Access Compliance Report Public Rights-of-Way (Pedestrian Signals)

Main Street: **BATAVIA_ST** Cross Street: **LINCOLN_AVE** Location: **SE**

ADA ID: **SGAT210924091702** Signal Type: **One Push Button-Non APS** Overall Compliance: **No** Severity Scores: **BTN 1: 10 BTN 2: N/A No BTN: N/A**

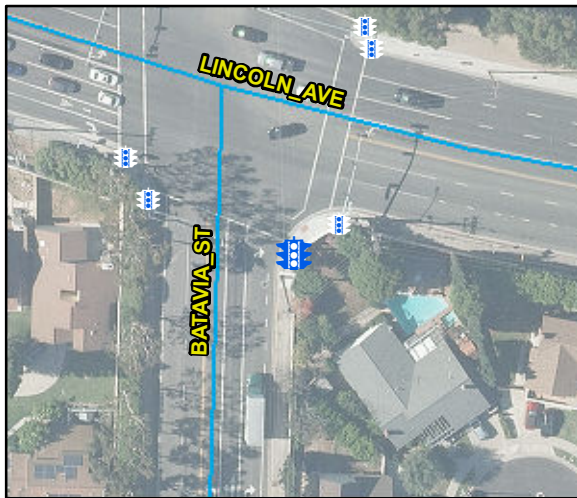
Possible Solutions: Replace Signal Push Button With APS Button.

OC Std/PROW: **MUTCD 4e.08**
